3 DESIGN REFINEMENTS

3.1 DESIGN REFINEMENTS SINCE DRAFT EIR PUBLICATION

Table 3.1-1. Design Refinements since the Draft EIR Publication

Figure 3.1-1. Design Refinements since the Draft EIR Publication

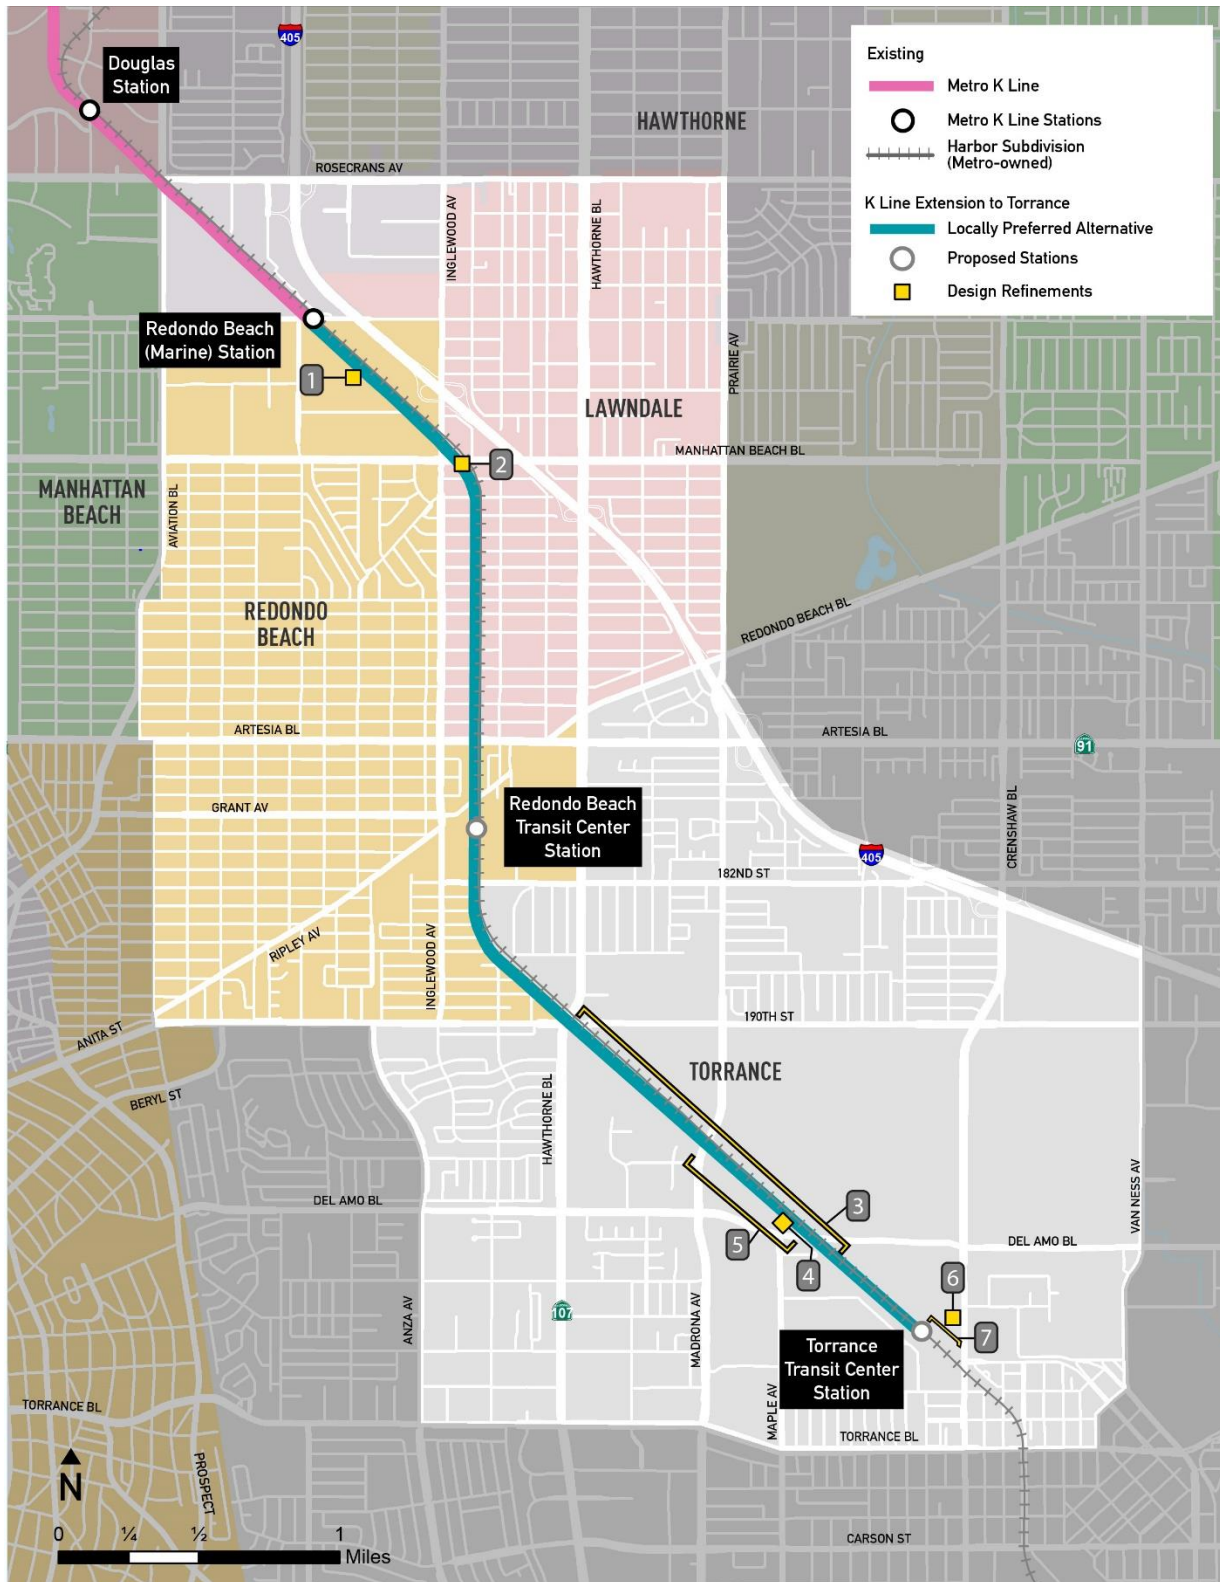
ID ¹	Location	City/ Jurisdiction	Reason for Refinement	Description of Refinement	Reference
1	Private Property: South of the Redondo Beach (Marine) Station, north of Santa Fe Avenue, west of Metro ROW	Redondo Beach	Based on further analysis of power needs and site access, an additional optional location for a Traction Power Substation (TPSS) was identified at the north end of the project. The new option would provide greater flexibility for maintenance operations and address potential challenges related to crane access at TPSS No. 1A.	The new TPSS option would be located on a parcel identified in the Draft EIR for permanent easement. The larger footprint required for the TPSS at this location could necessitate a larger partial acquisition or, if needed to accommodate all the elements of the project that impact the parcel, full acquisition of the property.	Appendix B, Select Advanced Conceptual Engineering Drawings - Locally Preferred Alternative, Page RW-302

2	Public Property: Manhattan Beach Boulevard crossing ²	Lawndale	In response to comments from the Metropolitan Water District (MWD) on the Draft EIR regarding a potential utility conflict with a cast-in-drilled-hole (CIDH) pile proposed in the center of Manhattan Beach Boulevard—specifically, its location above a MWD water pipeline—an alternate support location for the elevated light rail structure is proposed at this location.	The refined design for the elevated light rail structure would eliminate the CIDH pile within Manhattan Beach Boulevard and shift the proposed straddle bents—located within the Metro ROW—to the north and south of the boulevard. This change would avoid any potential conflict with the underground MWD pipeline, allowing it to remain in place during both project construction and operation.	Appendix B, Select Advanced Conceptual Engineering Drawings - Locally Preferred Alternative, Page TC-302 and RW- 304

3	Private Properties: Between 190th Street and south of Del Amo Boulevard	Torrance	Based on coordination with BNSF regarding the proposed freight track realignment, the design was refined to include a maintenance access path to serve the relocated freight tracks.	South of 190th Street, the railroad corridor would be widened by approximately five feet beyond what was included in the Draft EIR, to the southwest of the Metro ROW, to accommodate a maintenance access path for the freight tracks. This refinement would increase the area of partial acquisitions from industrial properties.	Appendix B, Select Advanced Conceptual Engineering Drawings - Locally Preferred Alternative, Page RW-313 through RW-318, T-314 through T-318

ID ¹	Location	City/ Jurisdiction	Reason for Refinement	Description of Refinement	Reference
4	Private Properties: North of Prairie Avenue, west of Metro ROW	Torrance	More detailed modeling of power demand for light rail operations indicated that minimum traction power voltage requirements may not be met with TPSS No. 5A, located near the Prairie Avenue overcrossing. To ensure adequate system performance, the design was refined to identify an alternate site (TPSS No. 5B) farther south, adjacent to the Del Amo Boulevard bridge.	TPSS No. 5B would be located to the north side of the Del Amo Boulevard bridge, on a parcel previously identified for acquisition as part of the project.	Appendix B, Select Advanced Conceptual Engineering Drawings - Locally Preferred Alternative, Page RW-318
5	Private Properties: Parcels (APN: 7352-015-005, 7352-015-006, and 7352-015-004) between Prairie Avenue and Del Amo Boulevard	Torrance	In response to comments from both Torrance Refining Company (TORC) and Torrance Logistics Company (TLC), the project design was refined to minimize the partial acquisition of the TORC property. This refinement addresses safety, security, and property concerns related to the TORC facility operations and compliance with applicable regulations.	Between north of Prairie Avenue and Del Amo Boulevard, the project footprint (including freight, light rail, and access roads) has shifted westward to avoid the TORC parcel. As a result, a larger partial acquisition would be required from the adjacent vacant parcel west of the rail corridor. This shift would also require additional modifications to the existing Prairie Avenue and Del Amo Boulevard bridges. At Prairie Avenue, a new box tunnel would be constructed to allow a realigned freight track and access road to pass beneath the roadway. At Del Amo Boulevard, the area beneath the bridge would be widened on the west to accommodate light rail and realigned freight and to provide sufficient clearance.	Appendix B, Select Advanced Conceptual Engineering Drawings - Locally Preferred Alternative, Page RW-315 through RW-318

6	City Property: City of Torrance Transit Center (APN: 7352-002-912)	Torrance	In response to comments from the City of Torrance, an alternative construction staging location has been identified, which would avoid potential conflicts with the City of Torrance’s proposed parking garage.	An alternate construction staging site has been identified on a parcel (APN: 7352-002-911) adjacent to the Torrance Transit Center on Crenshaw Boulevard. This adjustment would allow construction staging to proceed without interfering with the City of Torrance’s planned parking garage development.	Chapter 2, Description of the Locally Preferred Alternative, Page 2-36

ID ¹	Location	City/ Jurisdiction	Reason for Refinement	Description of Refinement	Reference
7	City Property: Torrance Transit Center Station Path	Torrance	In response to comments from the City of Torrance, the design was refined to address pedestrian safety and security concerns related to a segment of the proposed path connecting Crenshaw Boulevard to the Torrance Transit Center Station area. Specifically, the City raised concerns that the path could encourage pedestrians to cross Crenshaw Boulevard outside of signalized intersections.	The proposed path would provide pedestrian access from the light rail platform to the proposed bus plaza within the Torrance Transit Center. The segment of the proposed path that would have extended from the bus plaza to Crenshaw Boulevard has been removed from the design.	Appendix B, Select Advanced Conceptual Engineering Drawings - Locally Preferred Alternative, Page T-321

Figure 3.4-1. Area of TPSS Site 1B in the Draft EIR ACE (Top) and Final EIR ACE (Bottom)

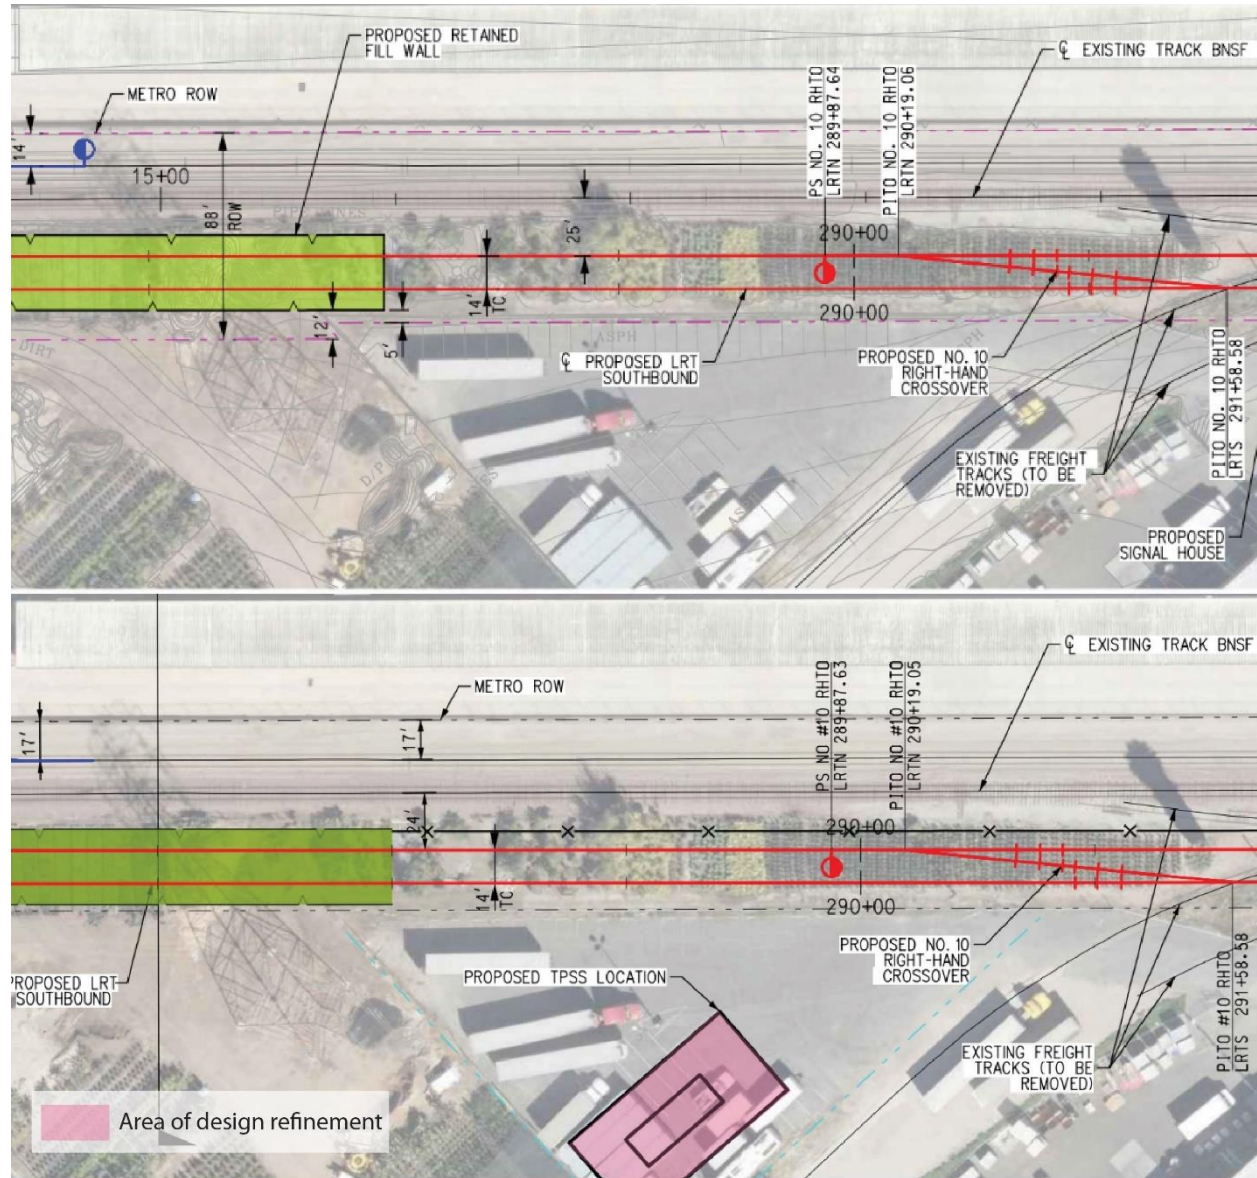
The Draft EIR stated that the project would require between four and six TPSSs. As described in Chapter 2, Project Description of the Locally Preferred Alternative, of this Final EIR, the LPA would require six TPSSs. Therefore, the total number of TPSS sites required for the project remains the same as stated in the Draft EIR, but two additional location options were identified as part of design refinements. Specifically, an alternate site for TPSS No. 1 (1B) was identified southwest of the existing Metro Redondo Beach (Marine) Station, adjacent to the Metro ROW north of Santa Fe Avenue, and an alternate site for TPSS No. 5 (5B) was identified adjacent to the Metro ROW immediately north of Del Amo Boulevard.

Figure 3.4-1 illustrates how the proposed TPSS design refinement sites correspond to the project component locations previously presented in Appendix 2-A, Select Advanced Conceptual Engineering Drawings, of the Draft EIR. These sites, as previously presented, included areas proposed for either new track and buildings or the expansion of existing structures. Although the installation and operation of a TPSS would introduce a new use within these sites, the uses would be of similar scale and intensity to the project components previously proposed in the Draft EIR.

Figure 3.4-3. Manhattan Beach Boulevard Crossing in Draft EIR ACE (left) and Final EIR ACE (right)

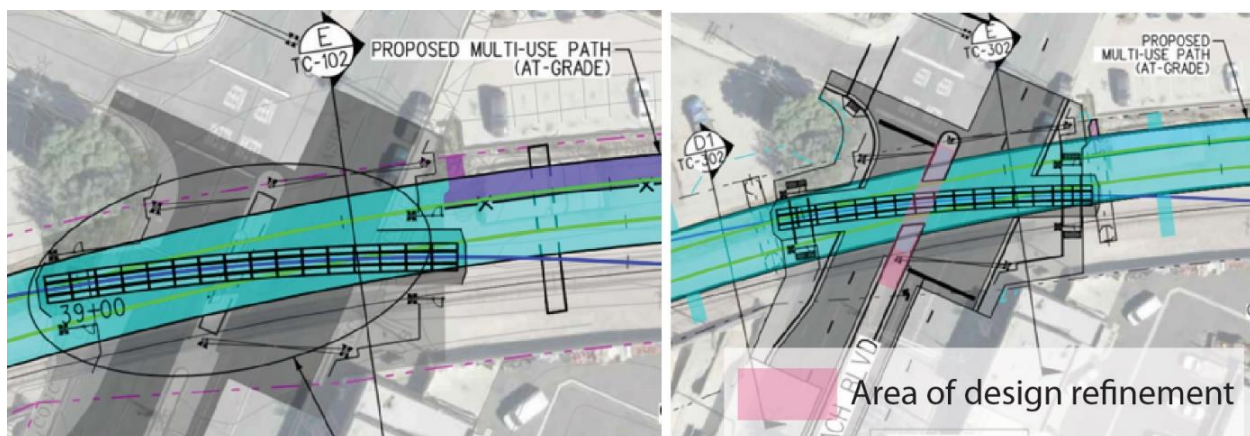
The Draft EIR analyzed an elevated structure crossing Manhattan Beach Boulevard that included a straddle bent with a center column located in the median of the roadway. The refined crossing would instead span the roadway without a center column. As shown in Figure 3.4-3, the refined crossing would cover approximately the same area as the original design. Drawings T-104 of Appendix 2-A of the Draft EIR and T-304 of Appendix B of the Final EIR further illustrate that the two designs are of similar height.

While construction methods would be slightly different between the Draft EIR and the refined design, both involve bridge structures of similar scale at the same location. As such, any variation in construction duration or technique would be minimal and would not affect the conclusions of the Draft EIR's analysis. The refined design differs from the original design primarily in its elimination of the median column and a slight lateral shift of the straddle bents on either side of the roadway. These adjustments would not result in new or more severe operational impacts compared to those identified in the Draft EIR.

Figure 3.4-8. Proposed ROW South of Del Amo Boulevard in Draft EIR ACE (top) and Final EIR ACE (bottom)

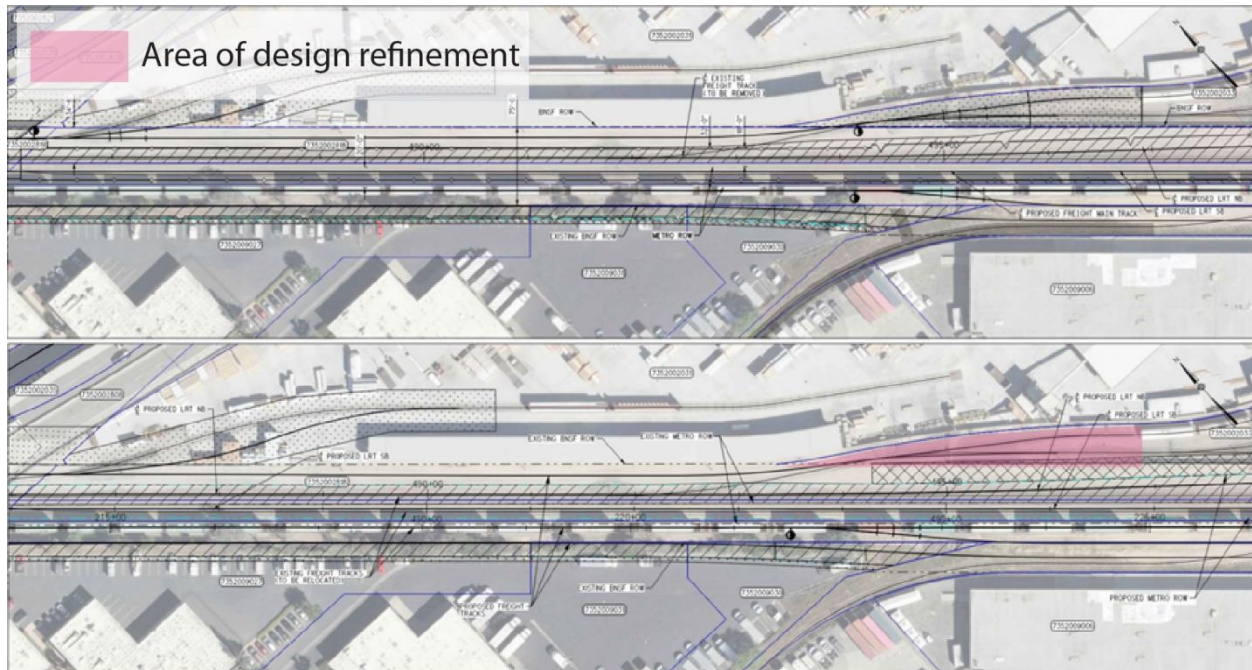
The Draft EIR evaluated track shifts and widening of the Metro and BNSF ROW south of 190th Street in the highly industrialized areas of the corridor in Torrance. After the publication of the Draft EIR, Metro continued coordination with local stakeholders, including BNSF and business or property owners adjacent to the Metro and BNSF ROW. Coordination with BNSF resulted in refinements to the project design to provide maintenance access paths parallel to freight tracks, which otherwise would have been no longer accessible from the edge of the ROW with the addition of light rail tracks. The addition of these maintenance access paths expanded the ROW approximately five feet to the southwest between 190th Street and just south of Del Amo Boulevard. Additionally, the proposed design of light rail, freight tracks, paths, and other ancillary facilities was shifted to the south between Prairie Avenue and Del Amo Boulevard to avoid encroachment into the Torrance Refining Company's property and ensure safe and secure operations. Such refinements further expand the ROW to the southwest in these areas. The latter refinement also resulted in modifications to the bridges at Prairie Avenue and Del Amo Boulevard, discussed further in Section 3.4-4.

Figure 3.4-4, Figure 3.4-5, Figure 3.4-6, Figure 3.4-7, and Figure 3.4-8 compare the ROW of the Draft EIR's Appendix 2-A, Select Advanced Conceptual Engineering Drawings, and this Final EIR's Appendix B, Select Advanced Conceptual Engineering Drawings - Locally Preferred Alternative, from south of 190th Street to South of Del Amo Boulevard. Figure 3.4-4 and Figure 3.4-8 show minimal expansion, by a matter of several feet into the adjacent industrial properties. Figure 3.4-5, Figure 3.4-6, and Figure 3.4-7 show more noticeable expansion into the adjacent industrial properties. In all cases, these impacts to properties do not require full acquisitions that would prevent them from continuing their business operations and are largely sliver takes of areas without permanent structures or equipment.

Figure 3.4-9. Prairie Avenue in Draft EIR ACE (left) and Final EIR ACE (right)

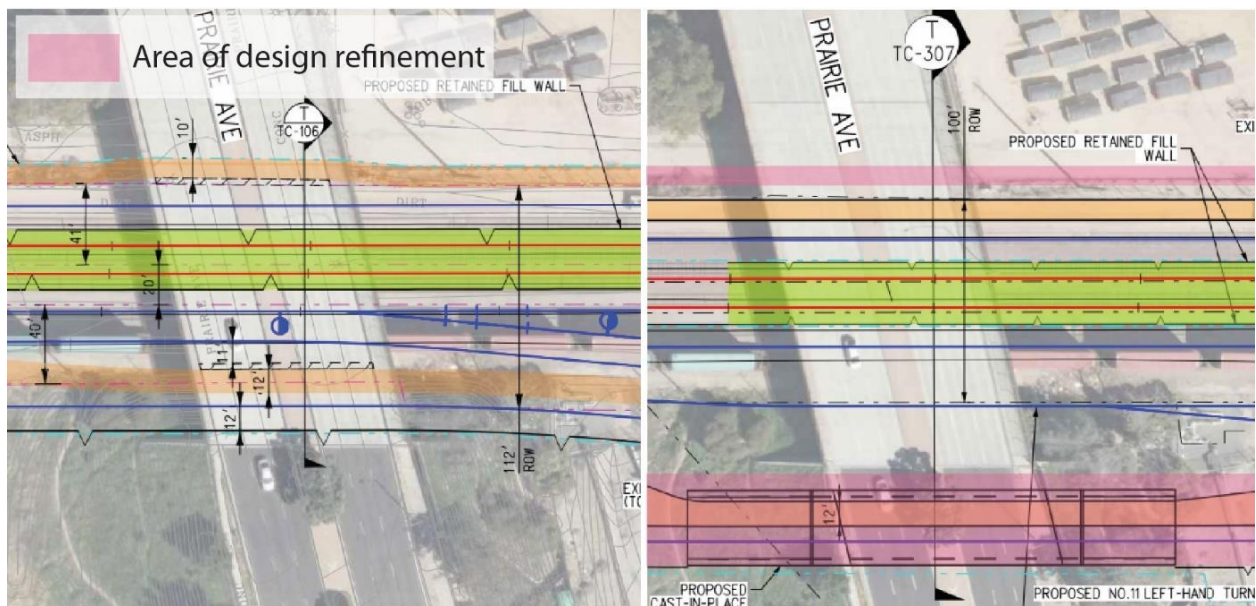
As described in Section 3.4-3 of this Final EIR, continued coordination after the publication of the Draft EIR resulted in shifting the design of the project southwestward, south of 190th Street. This shift in alignment resulted in changes to the proposed design of two roadway bridges that cross over the Metro and BNSF ROW: Prairie Avenue and Del Amo Boulevard. In the design analyzed in the Draft EIR, no major structural work was proposed at Prairie Avenue, as there was sufficient space to construct the required freight tracks on the southwest side of the ROW without modifying the bridge. In the refined design, however, a box tunnel would be constructed on the southwest side of the ROW to allow the realigned freight track to pass through. Figure 3.4-9 compares the Draft EIR's Appendix 2-A, Select Advanced Conceptual Engineering Drawings, and this Final EIR's Appendix B, Select Advanced Conceptual Engineering Drawings - Locally Preferred Alternative, at Prairie Avenue.

Figure 3.4-10. Del Amo Boulevard in Draft EIR ACE (left) and Final EIR ACE (right)

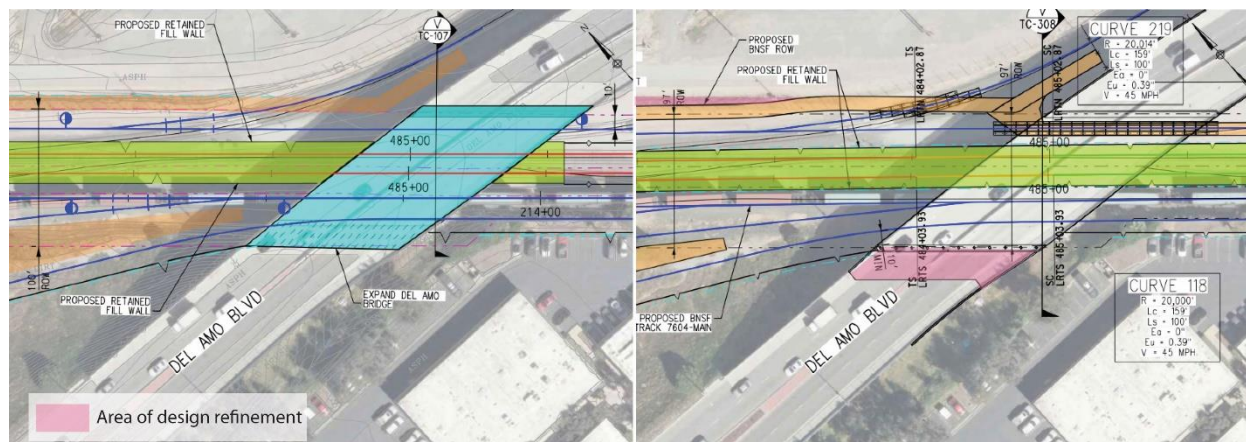
Analysis in the Draft EIR included demolition and replacement of the bridge deck at Del Amo Boulevard and expansion of the bridge using its existing abutments to accommodate shifting tracks. The proposed design refinement would require the demolition and replacement of the bridge deck and the west abutment to widen the ROW and accommodate the shifting freight tracks. Figure 3.4-10 compares the Draft EIR's Appendix 2-A, Select Advanced Conceptual Engineering Drawings, and this Final EIR's Appendix B, Select Advanced Conceptual Engineering Drawings - Locally Preferred Alternative, at Del Amo Boulevard.
